Access Compliance Report

Public Rights-of-Way

(Curb Ramps)

Intersection ID: 10038774	Main Street: STEELE_CREEK_RD	Cross Street: N/A	Location: NW
ADA ID: 860F3338E3A4	Ramp Type: Perp	Initial Pass/Fail: Fail	Overall Compliance: No
Severity Score: 12.5			
Codes/Mitigation Info/Possible Solution		Field Measurements/Component Compliance

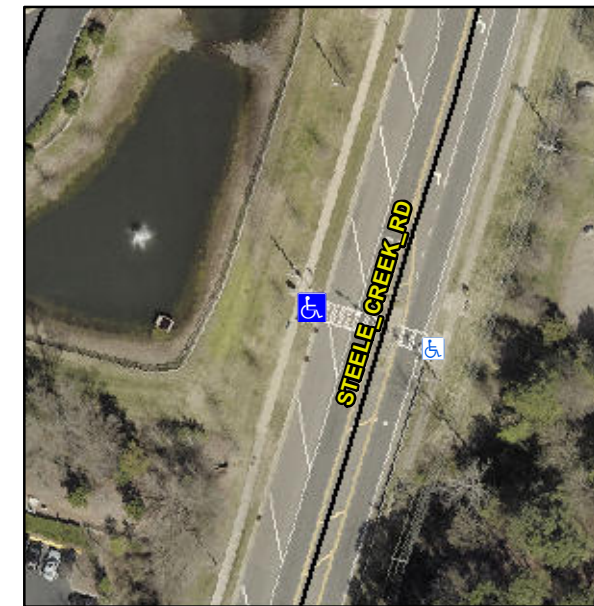
Not Found, R304.2.2

Compliance	Description	Data	Compliance	Description	Data
N/A	Ramp Length (in)	94.0	No	Ramp Slope (%)	10.0
Yes	Ramp Width (in)	48.0	Yes	Ramp XSlope (%)	1.2
N/A	Flare Type LT	N/A	N/A	Flare Type RT	N/A
N/A	Flare Slope LT (%)	N/A	N/A	Flare Slope RT (%)	N/A
N/A	Flare Traversable LT?	N/A	N/A	Flare Traversable RT?	N/A
N/A	Landing Length (in)	N/A	N/A	DWS Provided?	N/A
N/A	Landing Width (in)	N/A	N/A	DWS Contrast?	N/A
N/A	Landing Slope (%)	N/A	N/A	DWS Length (in)	N/A
N/A	Landing X Slope (%)	N/A	N/A	DWS Full Width?	N/A
N/A	Landing Curb? (Y/N)	N/A	N/A	DWS Offset (in)	N/A
N/A	Shared Landing?	N/A			
N/A	Gutter Ponding?	N/A	N/A	Gutter Slope (%)	N/A
N/A	Gutter Lip Ht (in)	N/A	N/A	Gutter X Slope (%)	N/A
N/A	Painted X Walk1?	Yes	N/A	Painted X Walk2?	N/A
	X Walk 1 Direction	To SE		X Walk 2 Direction	N/A
N/A	X Walk 1 Width (in)	110.0	N/A	X Walk 2 Width (in)	N/A
	X Walk 1 Slope (%)	3.1		X Walk 2 Slope (%)	N/A
	X Walk 1 X Slope (%)	0.2		X Walk 2 X Slope (%)	N/A

Remove & Replace Entire Ramp.
